CLIENT
ZANCOR HOMES

PROJECT/LOCATION
**OLDE WINCHESTER
BROOKLIN, ONT**

DRAWING
SITE GRADING PLAN

| LOT NUMBER | 137 |

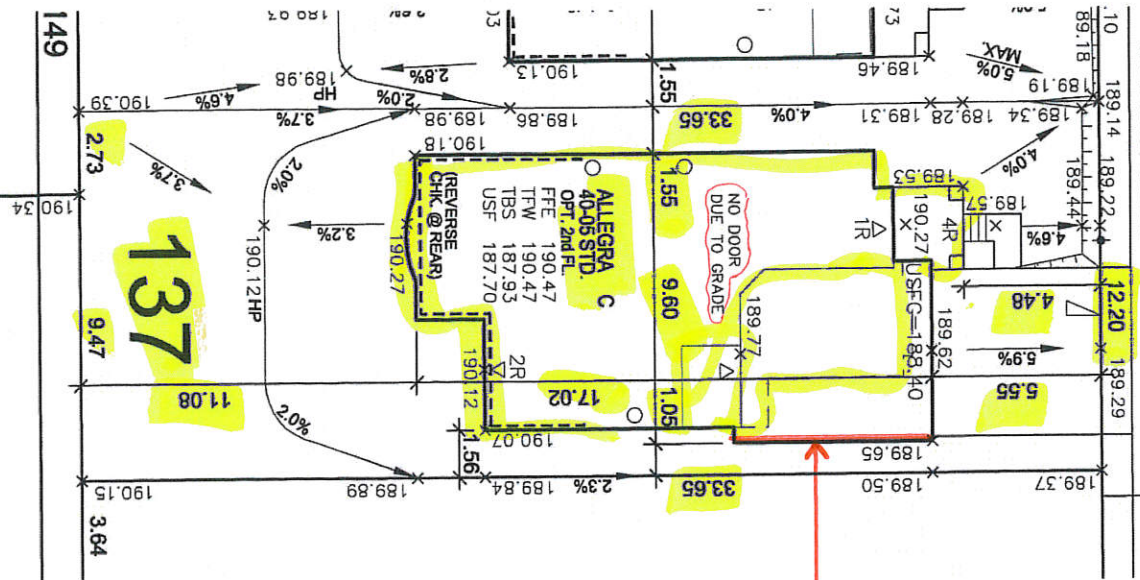
REQUIRED BY OBC 9.10.15.5.
EXPOSED BUILDING FACE AS
FIRE RESISTANCE RATING TO
MINIMUM 45 MINUTE

LOT GRADING PLANS APPROVED
SUBJECT TO REVISIONS NOTED
